The Town of Hilton Head Island Regular Design Review Board Meeting

Tuesday, March 22, 2011

DESIGN TEAM/ DRB COMMENT SHEET

PROJECT Ocean Walk Villas Phasing Plan

Phasing Plan
SP101

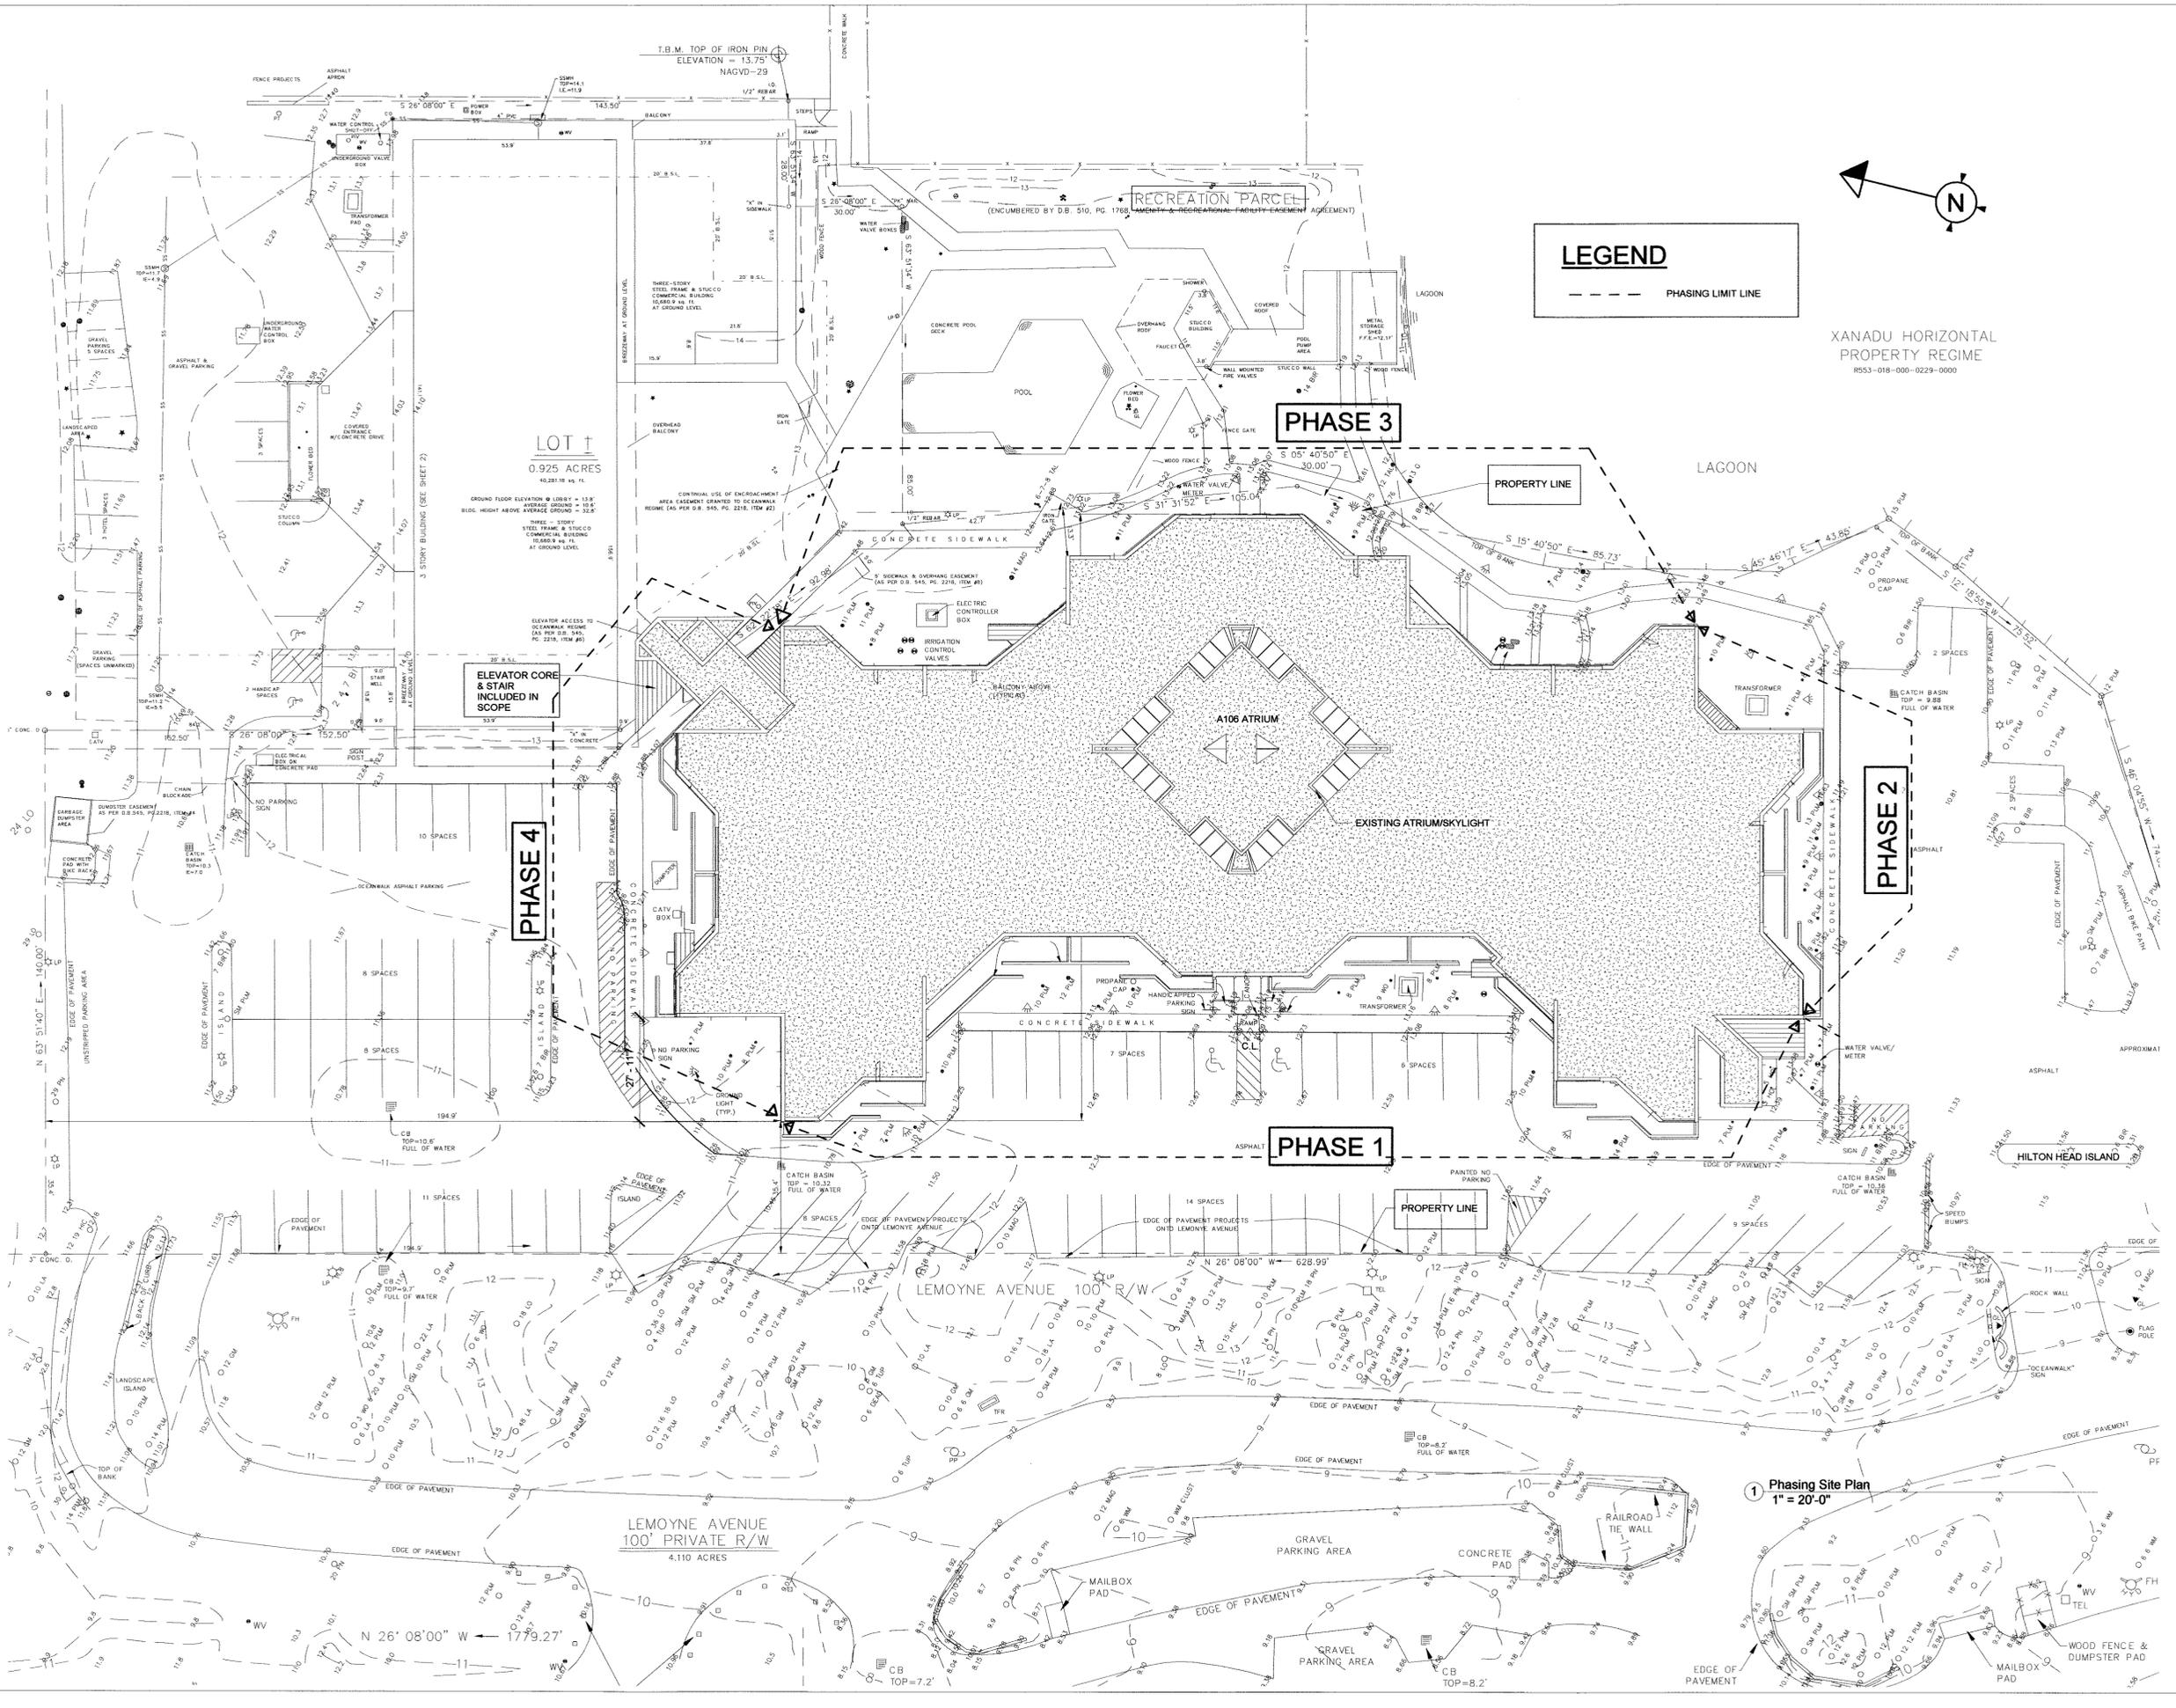
Applicant has logically re-phased the project and addressed all the Board's conditions. There are two different paint schedules submitted, incorporating the existing color and accents. The main difference is in the application of Finish #2, relative to the water table. Both options are included. Either meets the criteria of the Design Guide, and their respective merits can be discussed at the meeting. Hard color samples will be provided at the meeting

1400 MAIN STREET

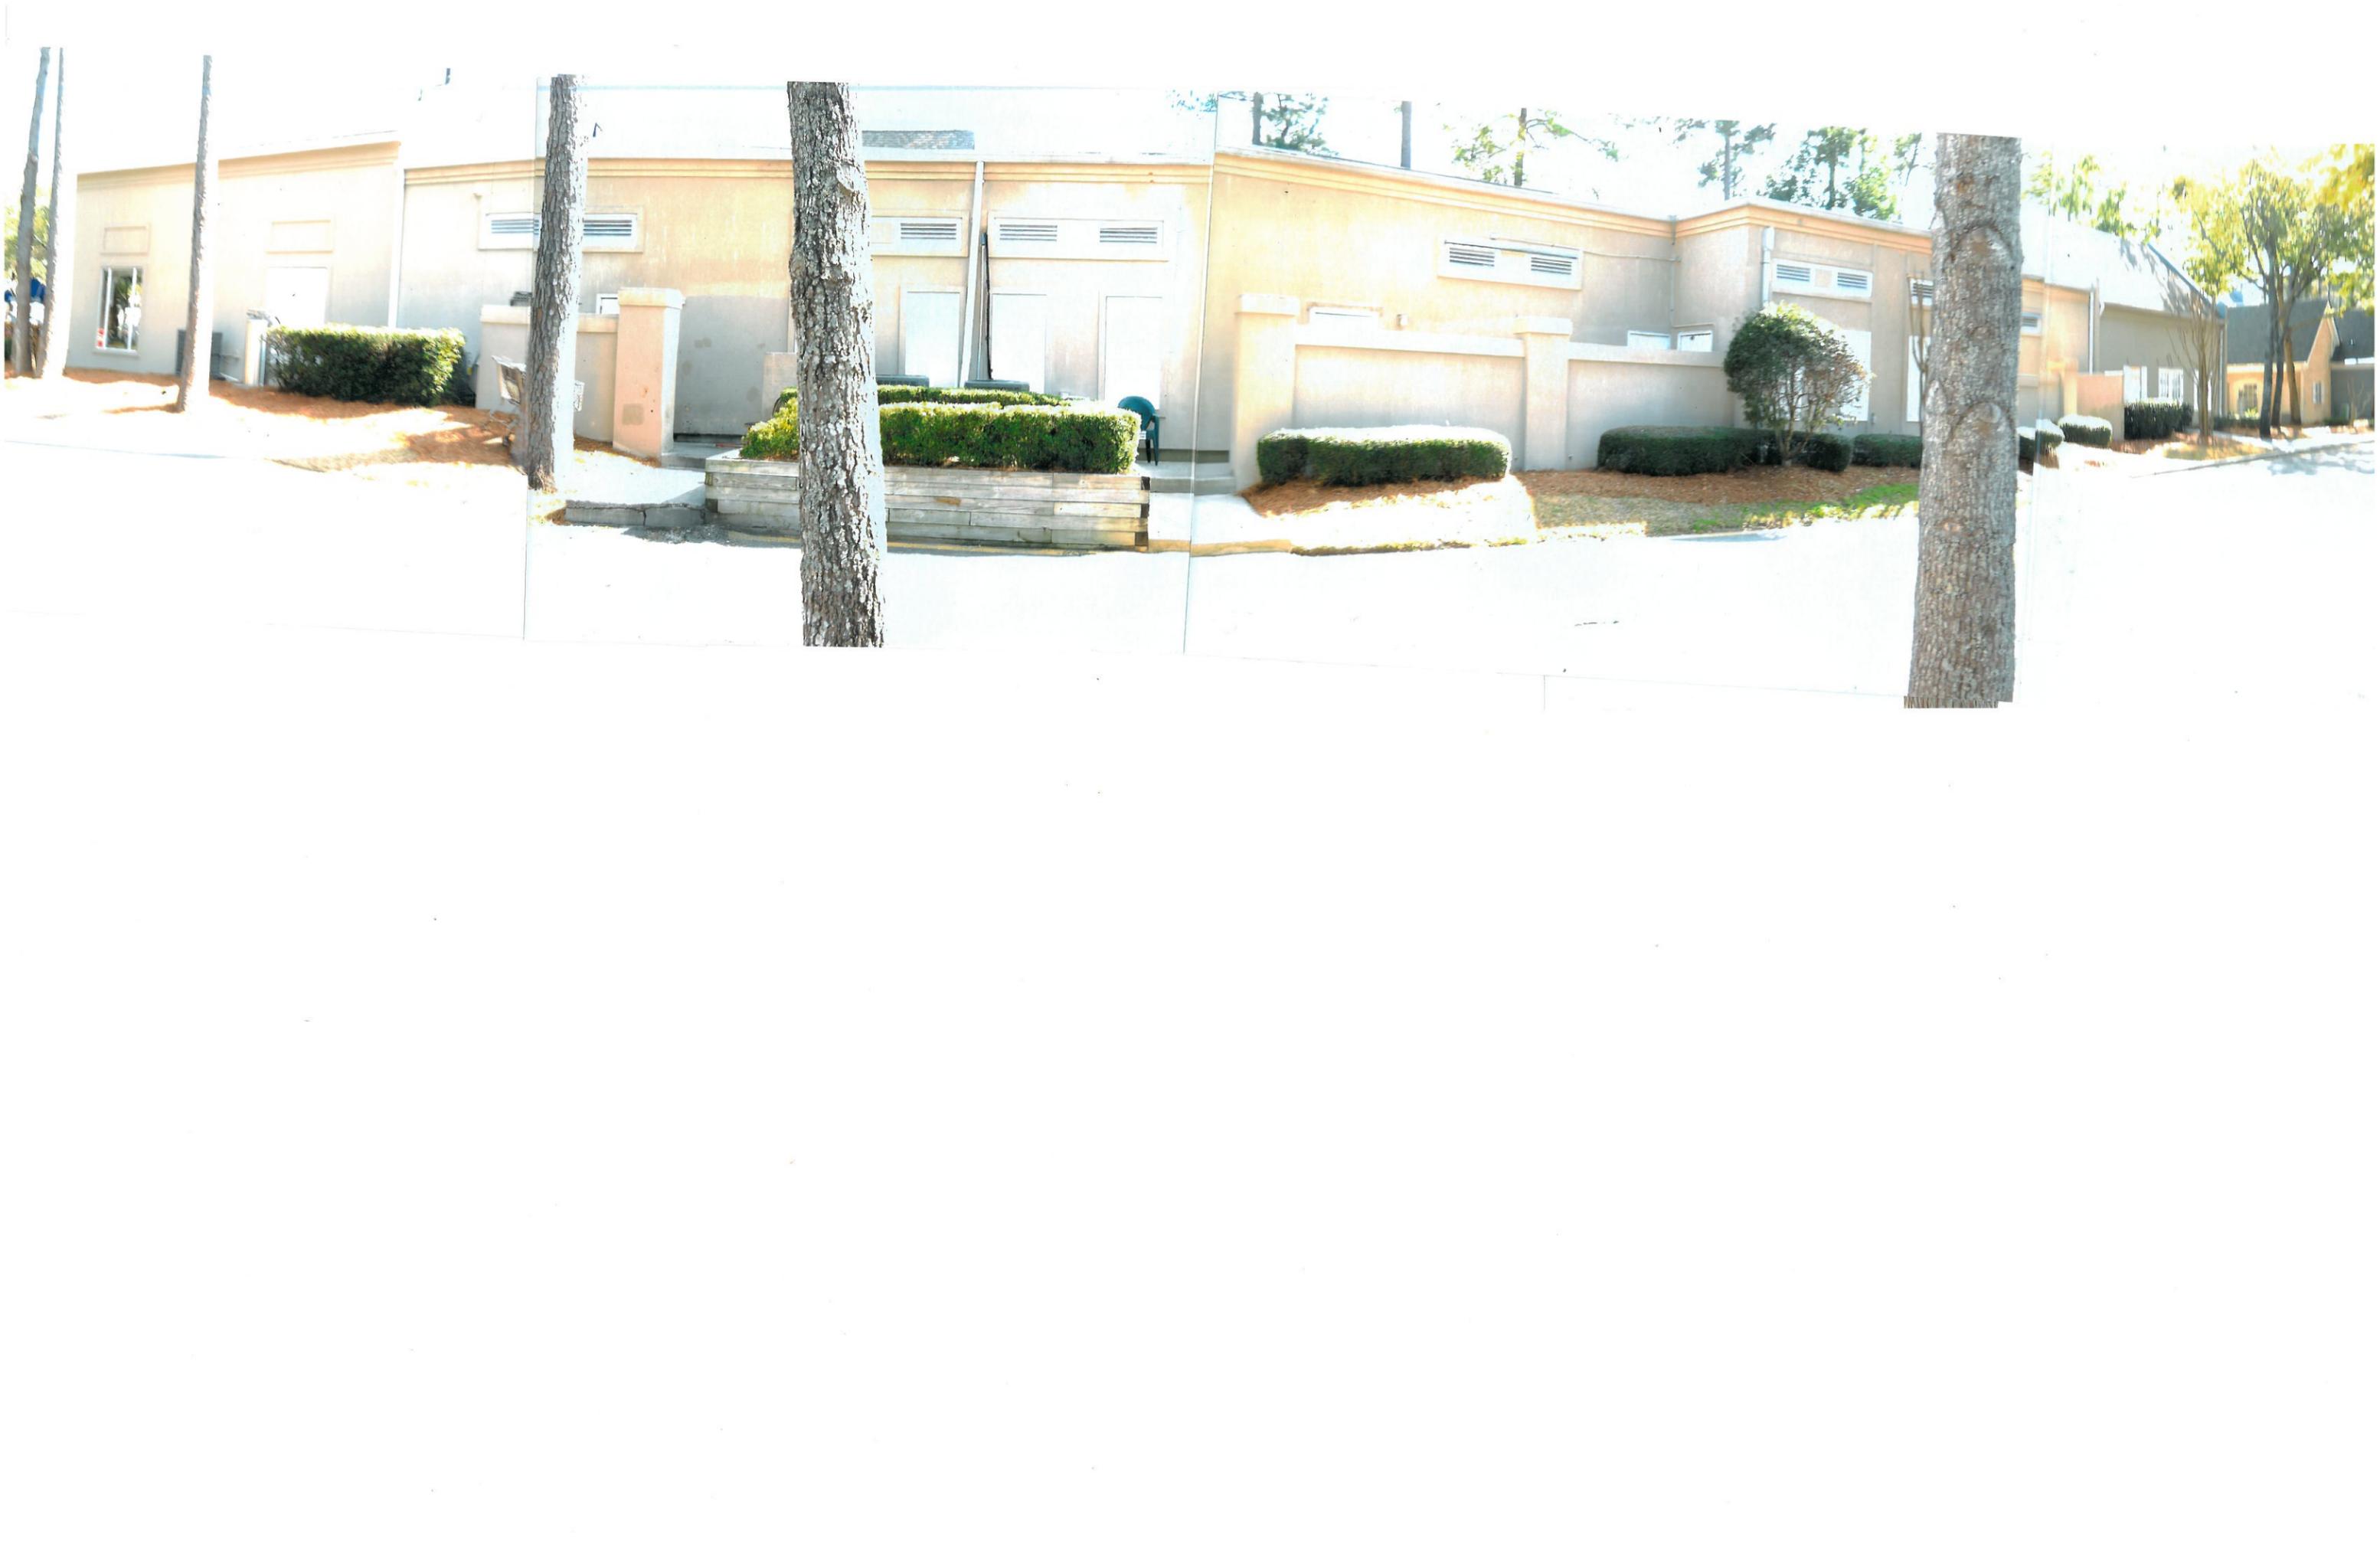
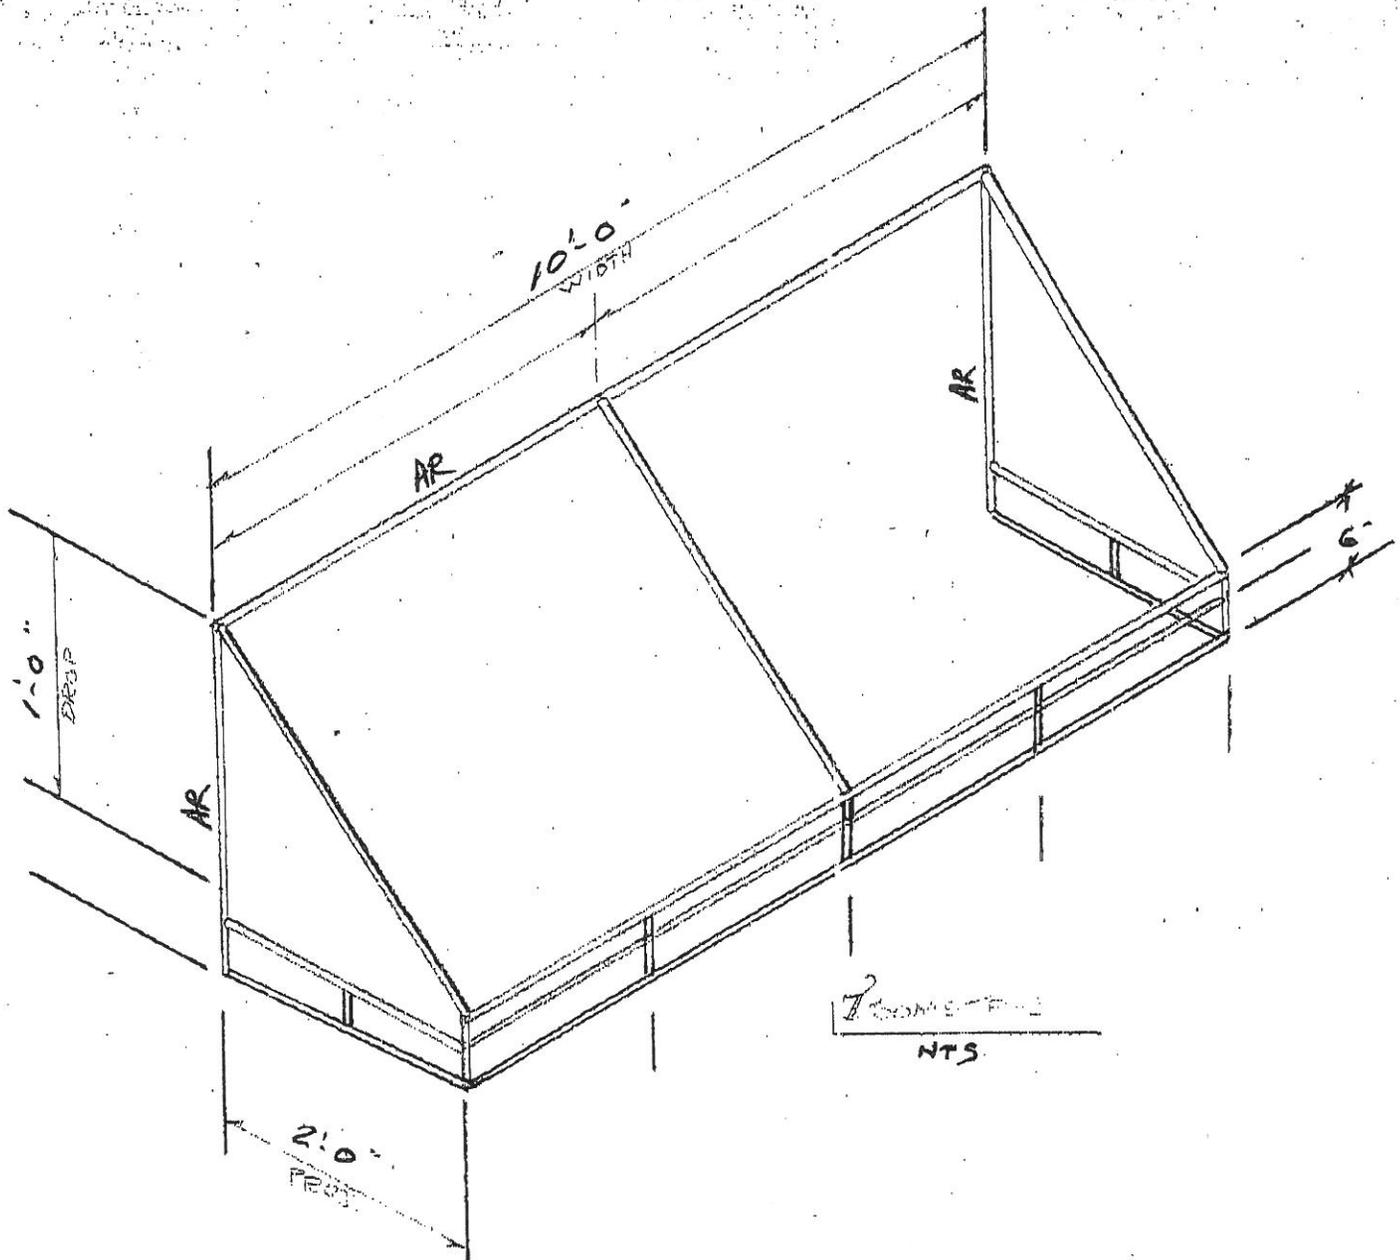
1. No new walls for construction, only repairs to existing
2. Applicant has offered including planting four (4) sabal palmettos, at the Board's request
3. The end units are not to receive new paint colors, so there is no potential mis-match around the corners
4. Numbered left to right, the applicant wishes to consolidate awnings 3 & 4, 7 & 8, 13 & 14

Still some details that need to be addressed relative to the relationship(s) between the awnings and pop-out trim, and a clarification of the paint color locations. Moving towards the Board's requirements for approval, but some points need to be clarified.

Some translation will be required between the "photo-rendering" of the landscaping and the photographs of the existing building.

1301 MAIN STREET

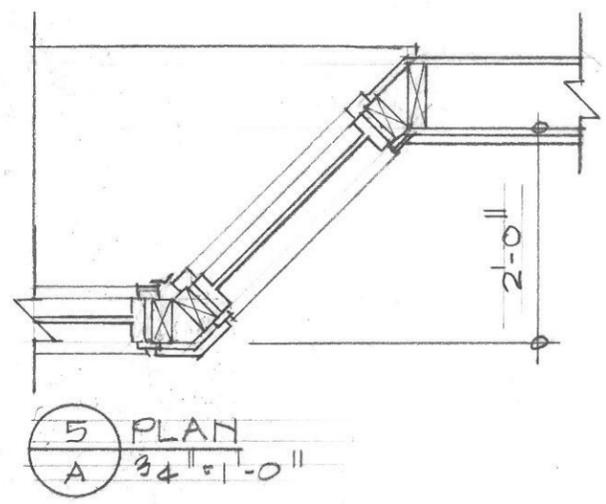
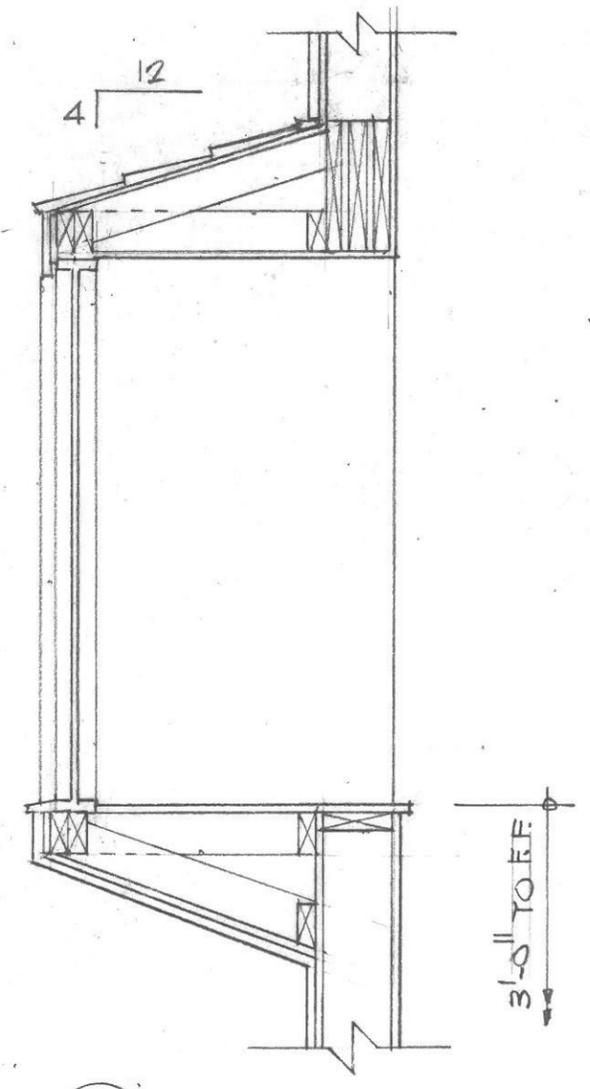
The staff believes that the change in fenestration feels slightly under-proportioned. And, while not recommended, if the bays are installed, they should be in keeping with the façade. The Board discussed the project and stated a strong preference for the existing window system versus the proposed bay window system. The existing window system has the correct scale and symmetry for the building. The applicant was not available at today's meeting for questions or comments from the Board. Following final comments, Chairman Theodore requested that a motion be made.

Mr. Behling made a **motion** to **deny** today's application for 1301 Main Street. Mr. Smith **seconded** the motion and the motion **passed** with a vote of 6-0-0.
